Mobile Intel® Celeron® Processor on .13 Micron Process in Micro-FCPGA Package

Specification Update

August 2003

Document Number: 251309-014

Figure 12. System Bus Reset and Configuration Timings

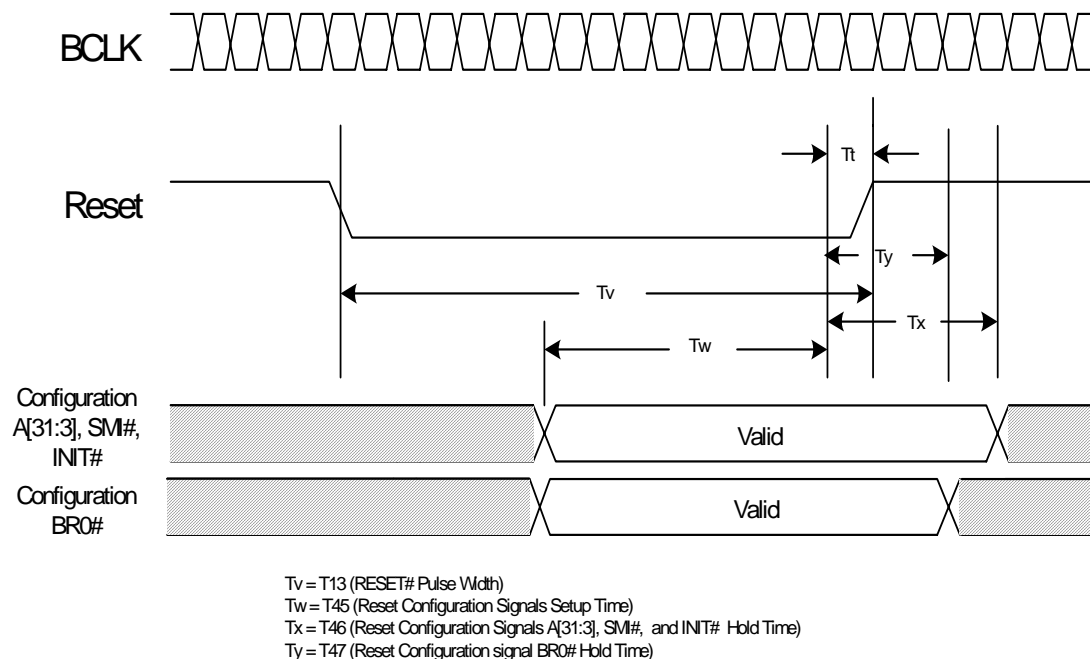
V2. BR0# Maximum Hold Time Specification Change

The BR0# maximum hold time has changed to 2 BCLKs. This change will be shown in the “System Bus AC Specifications (Reset Conditions)” table and “System Bus Reset and Configuration Timings” figure of the *Mobile Intel® Celeron® Processor on .13 Micron Process in Micro-FCPGA Package Datasheet*. This change will be incorporated in the next revision of the datasheet.

The following figure will be modified to reflect this change:
